PLANNING APPROVAL,
PLANNED UNIT DEVELOPMENT &
SUBDIVISION STAFF REPORT

NAME Weinacker's Montessori School, Inc.

SUBDIVISION NAME WMSHC Subdivision

LOCATION 227 Hillcrest Road
(East side of Hillcrest Road, 625'± South of Cedar Bend Court)

SITE PLAN

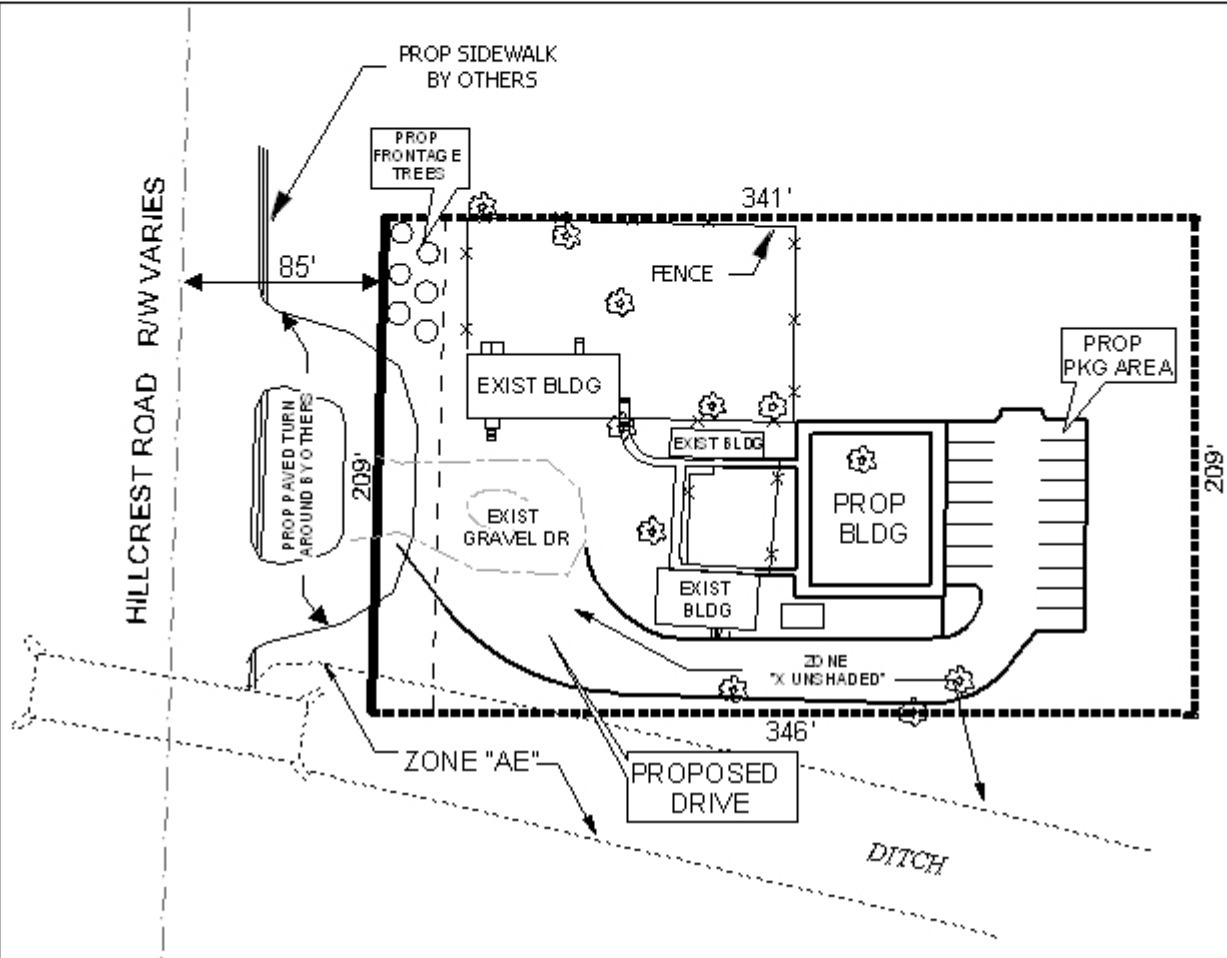
It also appears that several of the proposed parking spaces will require drivers to back into the right-of-way for Hillcrest Road. While the right-of-way at this location is approximately 150 feet wide, much wider than the 100 feet recommended by the Major Street Plan component of the Comprehensive Plan, backing into the right-of-way is not permitted by Section 64-6.A.2. of the Zoning Ordinance. The parking area should be redesigned so that all circulation related to parking and pick-up and drop-off activities occur fully on the site, and that the dimensions for the parking and circulation comply with the standards listed in the Zoning Ordinance.

A dumpster or other waste facility is not depicted on the site plan, however, it is assumed that wastes are generated by the site. Since the site is a commercial use, waste must be removed from the site by a private service, thus if dumpsters are used, they must comply with the screening requirements of the Zoning Ordinance and be depicted on the site plan.

Finally, a protection buffer strip should be provided along the North, East and South perimeters of the site, in accordance with Section 64-4.D.1. of the Zoning Ordinance.

Regarding on-site circulation, gravel cannot be used as a maneuvering or parking surface, thus the site plan should be revised to clearly show asphalt where the "existing gravel drive" is labeled. The "existing gravel drive" area also appears to have excessive width, thus a redesign of this area is recommend, perhaps providing a traffic circle type facility to allow parents to easily circle to drop-off and pick-up children, and allowing school staff access to the parking area in the rear.

The site plans should be revised to depict a fence or protection buffer strip along the North, East and South perimeters of the site, in accordance with Section 64-4.D.1. of the Zoning Ordinance.

- 4) Revision of the site plan to clearly depict paving of all vehicular circulation and parking areas, and revision of the front "existing gravel drive" area to reduce the excessive driveway width or provide a circular pick-up and drop-off facility with central landscaped area;*

- 7) Revision of the site plan to clearly depict a fence or protection buffer strip along the North, East and South perimeters of the site, in accordance with Section 64-4.D.1. of the Zoning Ordinance;*
